MELLON PROPERTIES COMPANY
WESTSIDE PLACE SUBDIVISION
P.O.A.D.P.

Re: Westside Place POADP # 578

The City Staff Development Review Committee has reviewed Westside Place Subdivision Preliminary Overall Area Development Plan # 578. Please find enclosed a signed copy for your files. Although your plan was accepted, please note the following:

REQUEST FOR REVIEW

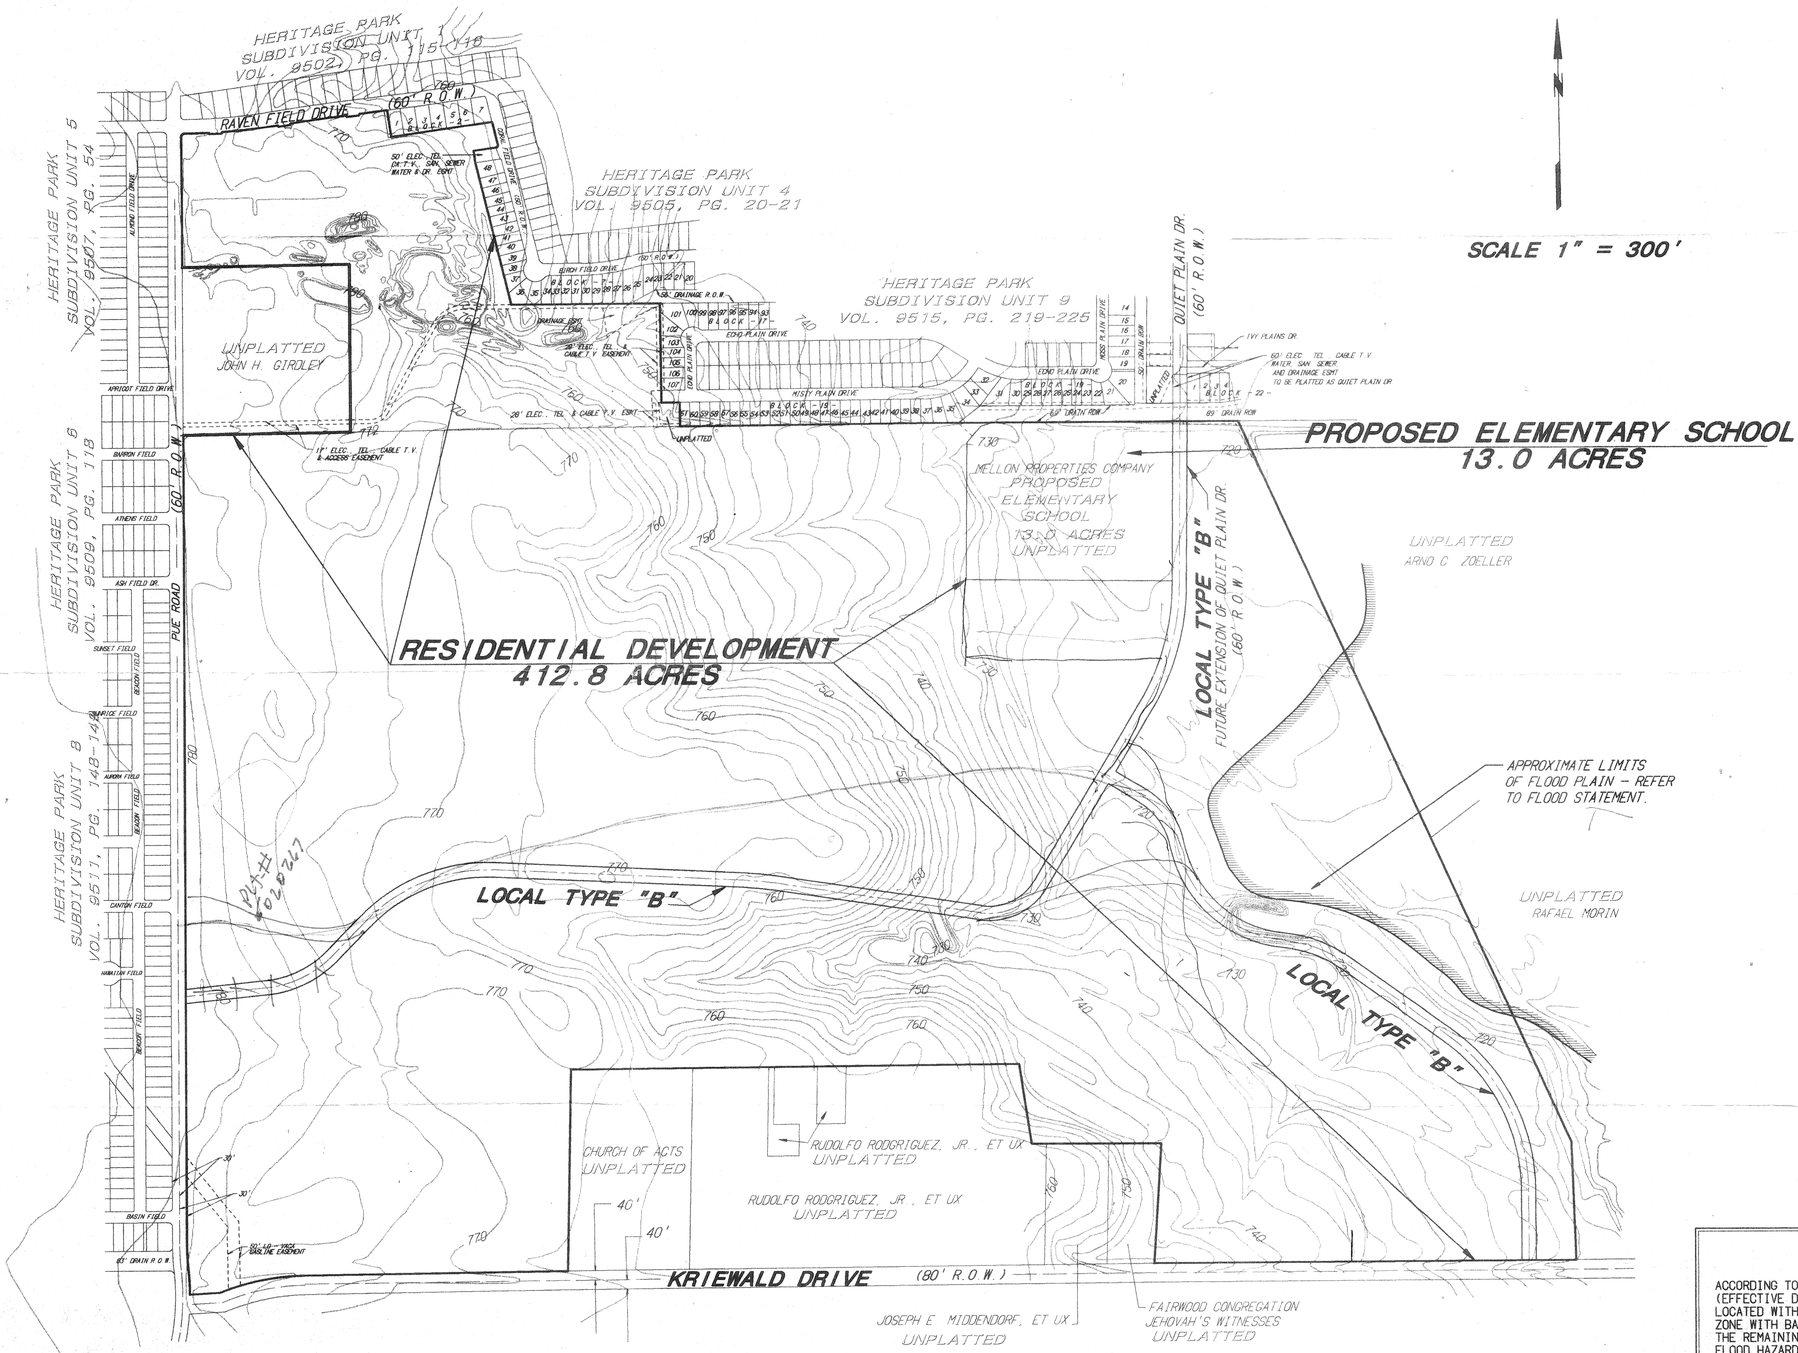
- Staff recommends that there be no residential frontage on Pue.
- Based on the topography, a Flood Plain Study and drainage review will probably be required during the platting process.
- This development will need to comply with tree preservation ordinance #85262. For additional information about these requirements you can contact Building Inspections at 207-7102.

Comments: Flood plain requirements and drainage easements will be required and will be address during the platting process

- tree
- drainage
- TIA
- no lot front on Pue
- ~~Where is the commercial~~
- Why local "B" instead of "A"
- ownership
- info on unplatted lots

- esement/connector for school
- connection w/ stub street. Misty Place Drive
